ADDENDUM #3

June 16th, 2022

RFP AP21-13

Alexandra Park Phase 2A –Electrical

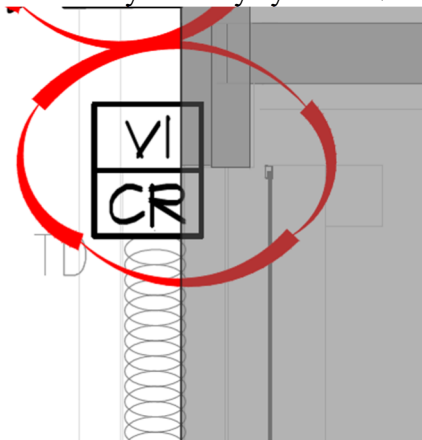
Question 1: Please clarify security symbol ‘VI’.

Answer: Security symbol ‘VI’ represents a Video Intercom Unit. A revised Cover Sheet for LOBO Security Drawings now indicates the above symbol in the Security Legend and is included with this addendum (**Appendix IX**).

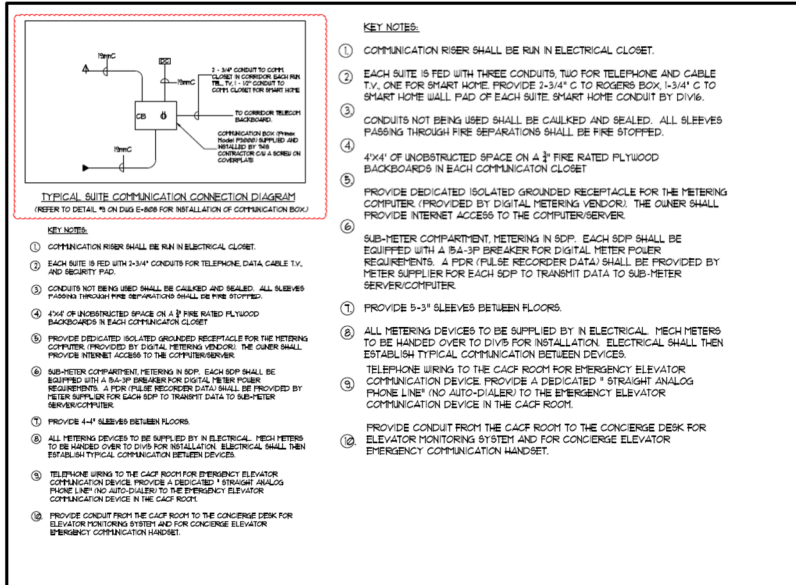
Question 2: Can you please clarify home run requirement for suite communication for MRKT Site 1. The diagram is showing 2 x ¾” home run, however, note 2 says 3 x ¾” home run. One homerun is to the suite smart panel? Where is this item, the drawings do not show a smart home panel?

Answer: The home run conduit requirements from the electrical closet to each suite Communication box has been revised on Novatrend Electrical Addendum E-2 to now only require 1 qty -1-1/2" conduit with Maxcell liner. The suite smart panel for MRKT Site 1 is not a wall mounted smart panel but will be an independent tablet that is not wall mounted and does not require any conduit or power requirements.
